UNITED STATES
DEPARTMENT OF THE INTERIOR
BUREAU OF LAND MANAGEMENTFORM APPROVED
OMB NO. 1004-0135
Expires: July 31, 2010**SUNDRY NOTICES AND REPORTS ON WELLS**
*Do not use this form for proposals to drill or to re-enter an abandoned well. Use form 3160-3 (APD) for such proposals.*5. Lease Serial No.
NMLC068368

☒ Oil Well ☐ Gas Well ☐ Other8. Well Name and No.
NORTH INDIAN FLATS 13 FEDERAL 12. Name of Operator
BOPCO LPContact: WHITNEY MCKEE
E-Mail: wbmckee@basspet.com9. API Well No.
30-015-41467-00-X1

BOPCO, L.P. respectfully requests to amend the BOP/BOPE information in the APD to include an 11" system that Cavaloz rig 3 utilizes.

Diagram A

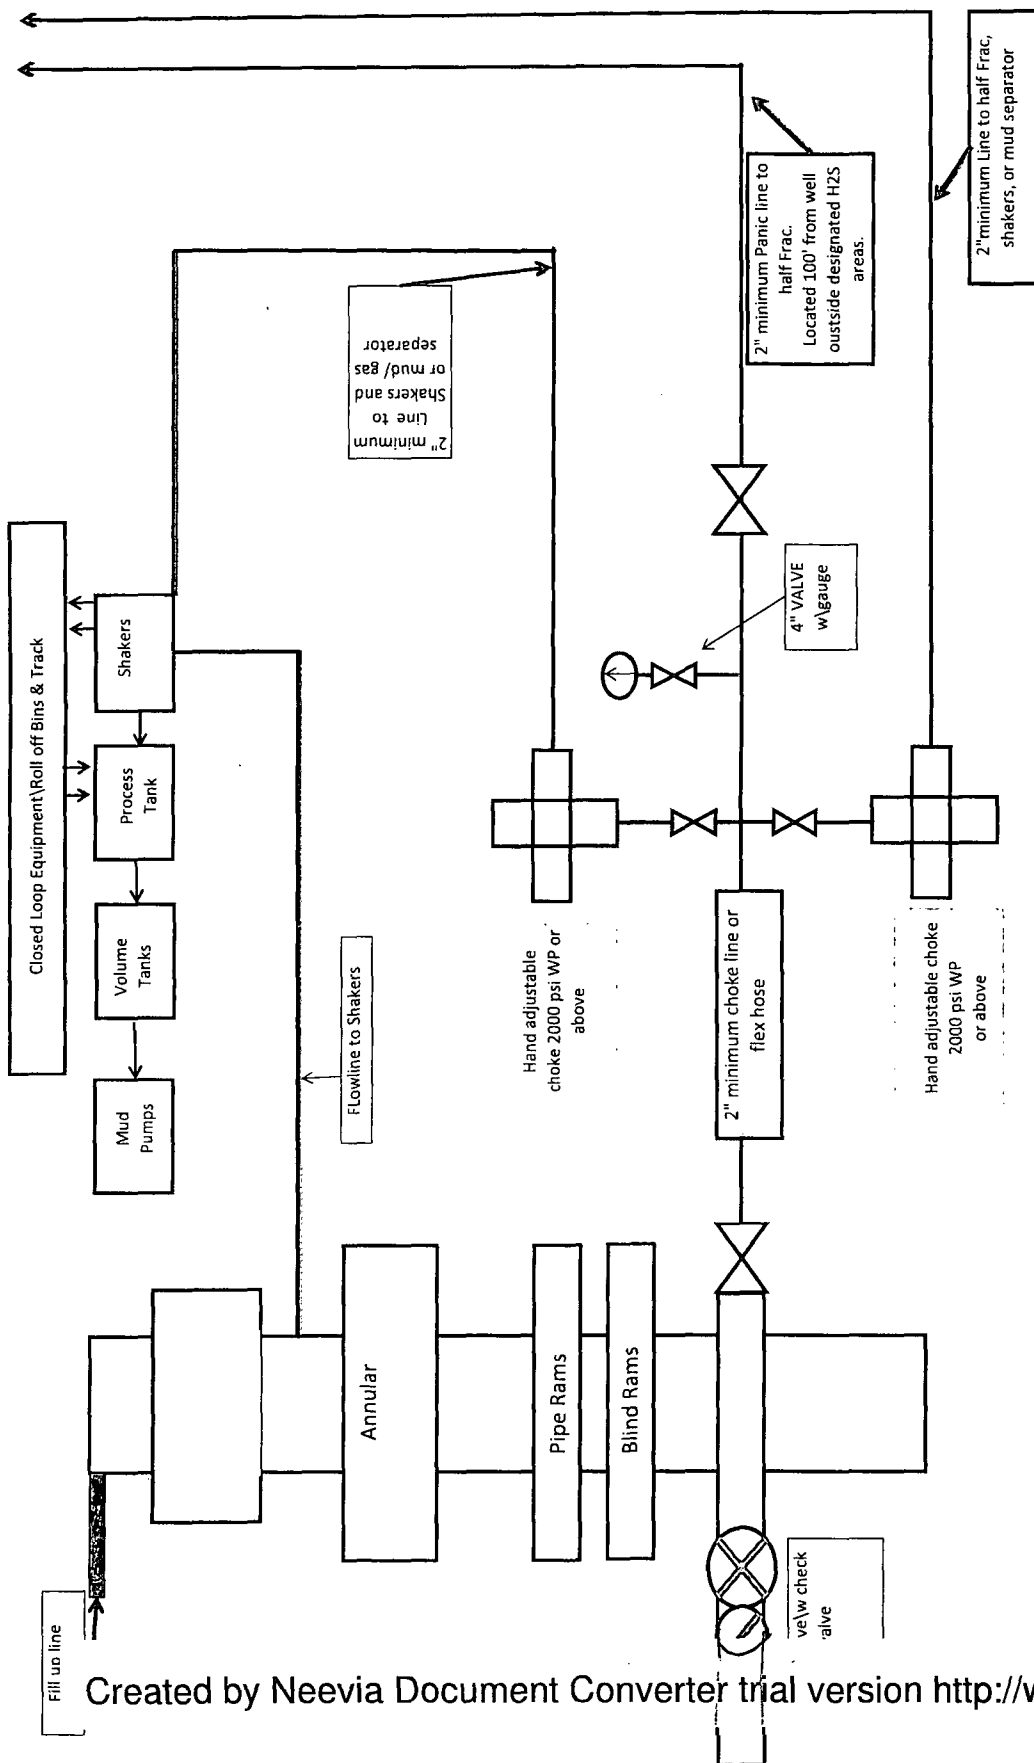
After running the 8-5/8" surface casing, a 11" BOP/BOPE system with a minimum rating of 2M will be installed, used, maintained and tested as per Onshore Order 2. In addition to the high pressure test, a low pressure (250-300 psig) test will be performed. Please see attached Diagram A.
